**Re: Initial Submission Review – E-470 and 6<sup>th</sup> Pkwy – Infrastructure Site Plan and Plat**  
Application Number: **DA-2134-02**  
Case Numbers: **2022-6033-00; 2022-3050-00**

## Initial Submission Review

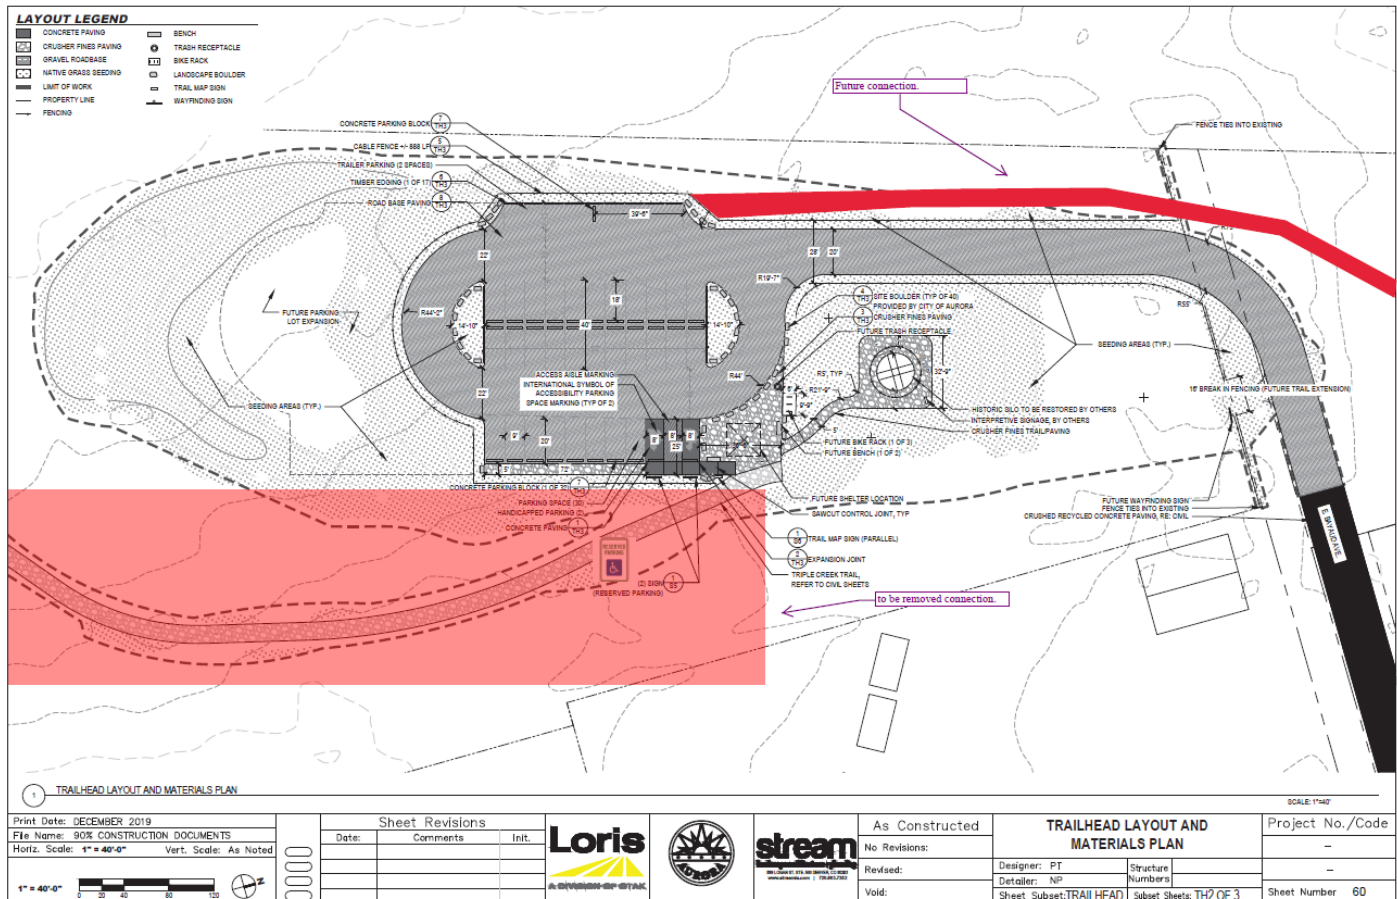
- 12A. Note the required 25' special landscape buffer.
- 12B. There needs to be a connection from the trail to the rest of the development. It could be a low water crossing if needed.
- 12C. Further coordination with PROS will be required. It does not appear that having this trail connect out this far would be necessary when the trailhead would likely be to the south.
- 12D. Plans for the future trailhead have not been finalized. It may be placed to the north or south of the parcel.
- 12E. The trail needs to be shifted on the property within the drainage channel.
- 12F. Note the COA parcels to the south.
- 12G. The future trailhead for the Triple Creek Trail will be located to the south of this development. The proposed trail connection being provided should extend to the south to provide the future connection to the trailhead. See design below.

- The proposed trail connection provided by the development will be on the north side of E. Bayaud Avenue and will need to extend to the west side of the proposed trail head, for clarification the current alignment shows the trail on the east side of the trailhead and will need to be realigned to avoid street crossings.
